NSW Independent  
Planning  
Commission

Pitt Street South  
OSD

INTERNAL AMENITY  
SUBMISSION

18 March 2021  
Final

## TYPICAL PLAN

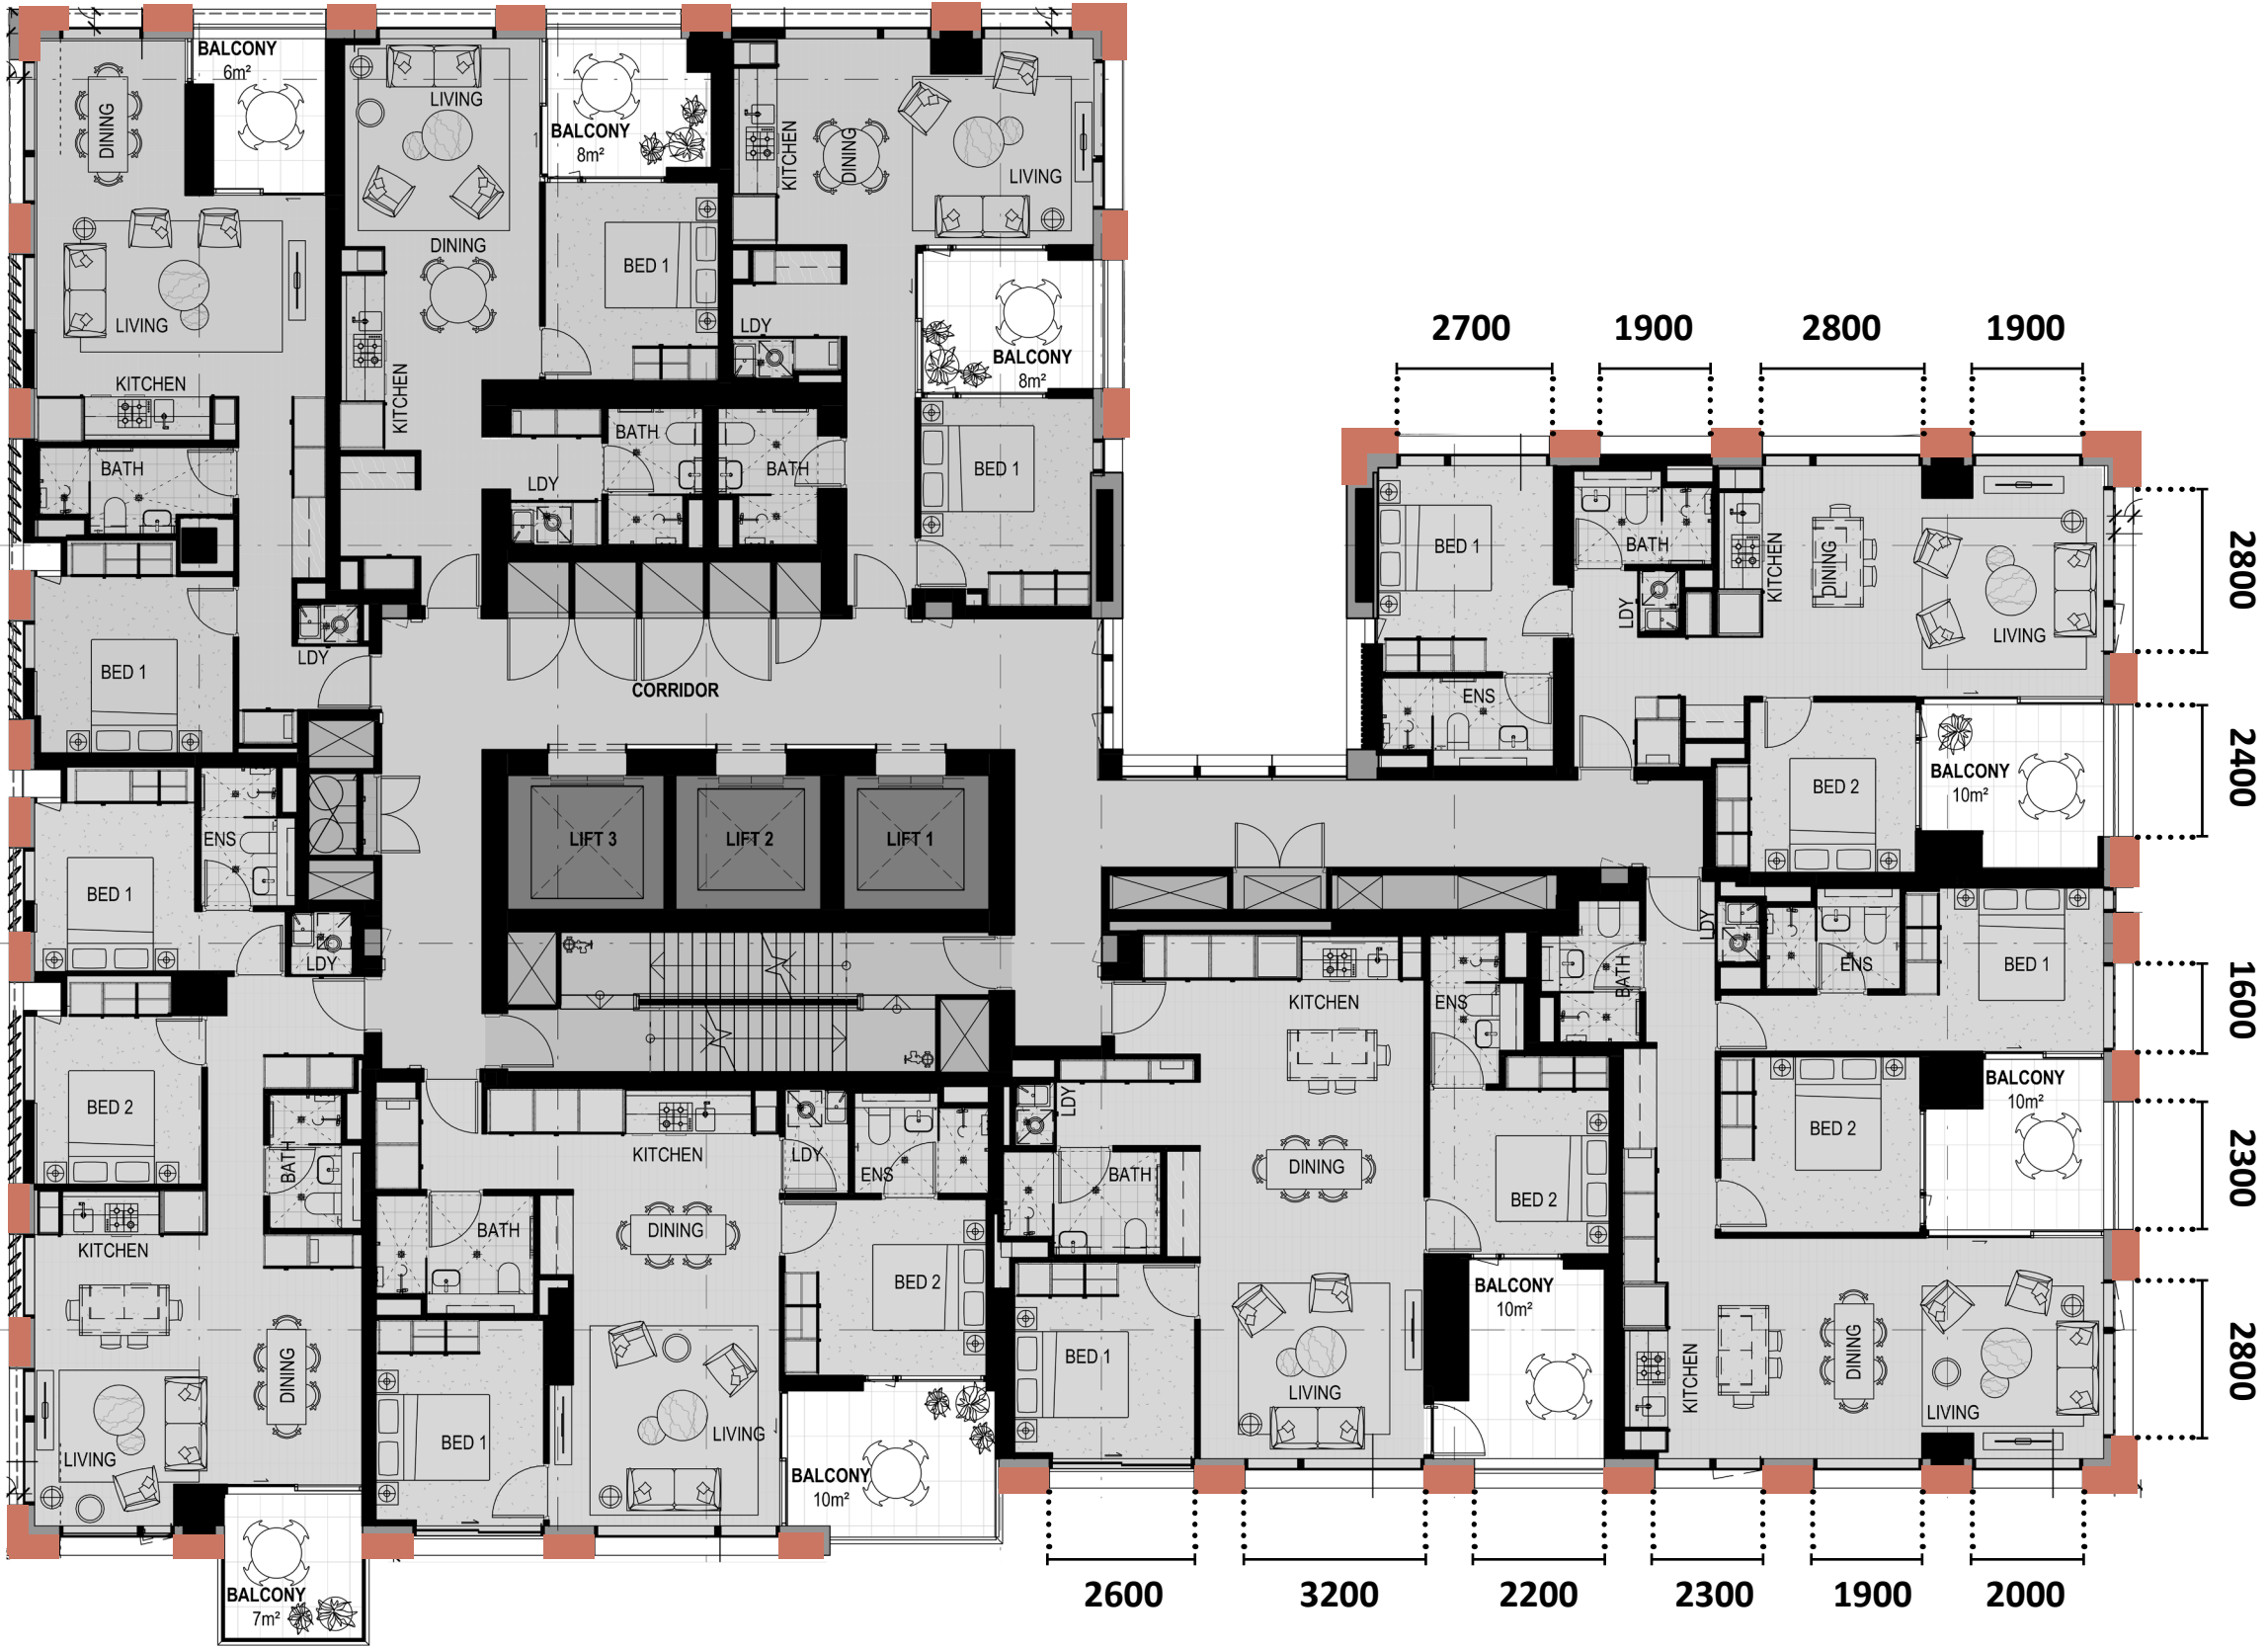
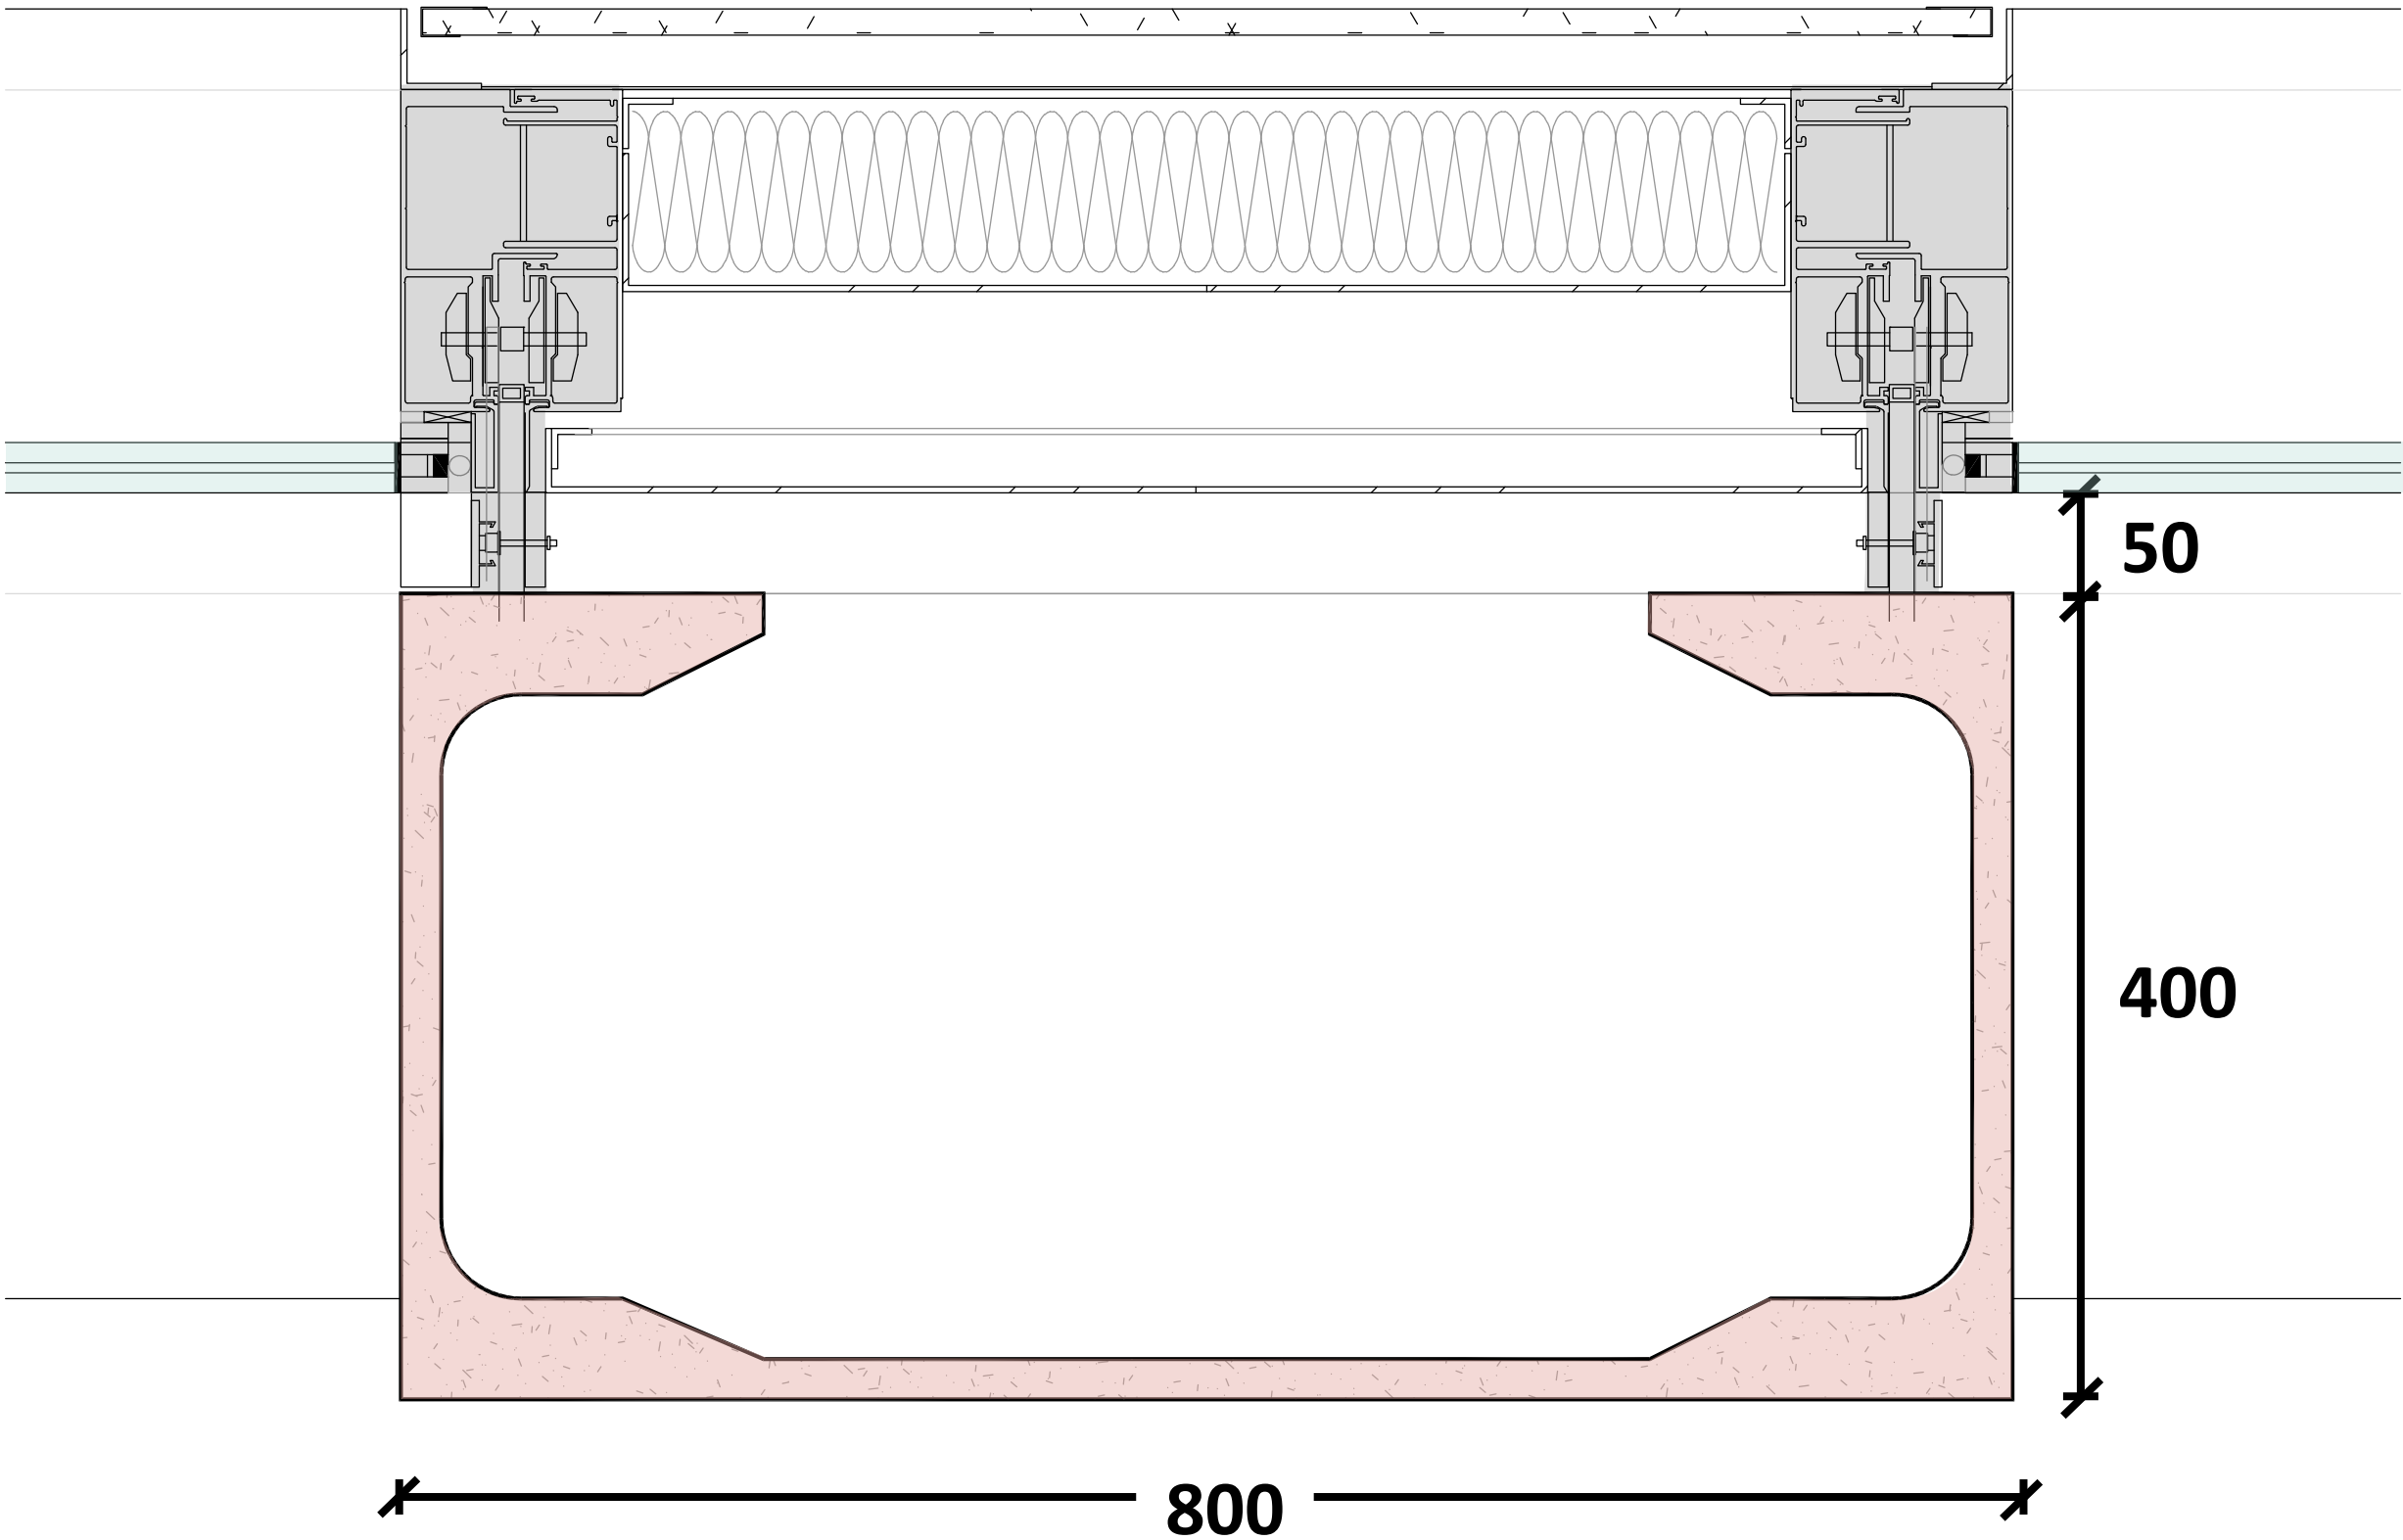
The Panel requests an urgent comparative analysis (of % of solid vs glazing) is provided of the Stage 2 DA façade vs the current proposed façade, prior to resubmission – in order to ascertain the overall impact. The comparative analysis should consist of elevations, plans and 3d views.

*The Panel requests an urgent **comparative analysis (of % of solid vs glazing)** is provided of the Stage 2 DA façade vs the current proposed façade, prior to resubmission – in order to ascertain the overall impact. The comparative analysis should consist of elevations, plans and 3d views.*

At DRP #12, All solid elements were increased to 900mm wide and 10 solid elements were proposed to be removed resulting in a total of **41 solid elements** (excluding lightwell):

Two additional solid panels were removed to even up the spacing between verticals, resulting in a total of **39 solid elements** (excluding lightwell). To avoid an increase in glazed area, we amended the GRC to Facade fixing, removing the 50mm fixing zone gap and offsetting the mullion to either side. This eliminated a gap with visible fixings and also reducing the glazed area by a further 50mm either side of the 900 wide GRC element.

As per DRP #13 plan with **39 solid elements** but with 400mm deep GRC as opposed to 325mm deep.

SSDA:	DRP #12:	DRP #13:	PROPOSED:
SOLIDS PER FLOOR:	51	41	39	39
GRC WIDTH P/ELEMENT:	800 / 900	900	900	900
SOLID WIDTH P/ELEMENT:	800 / 900	900	900	900
GRC DEPTH:	400mm	250mm	325mm	400mm
EXTERNAL FACADE DEPTH:	450mm	300mm	325mm	450mm
TOTAL LENGTH SOLID:	46.1m	42.3m	40.2m	40.2m
TOTAL LENGTH GLASS:	83.6m	87.2m	89.3m	89.3m
GLASS TO SOLID RATIO:	1.81 : 1	2.06 : 1	2.22 : 1	2.22 : 1
PERCENTAGE OF SOLID:	35%	33%	31%	31%
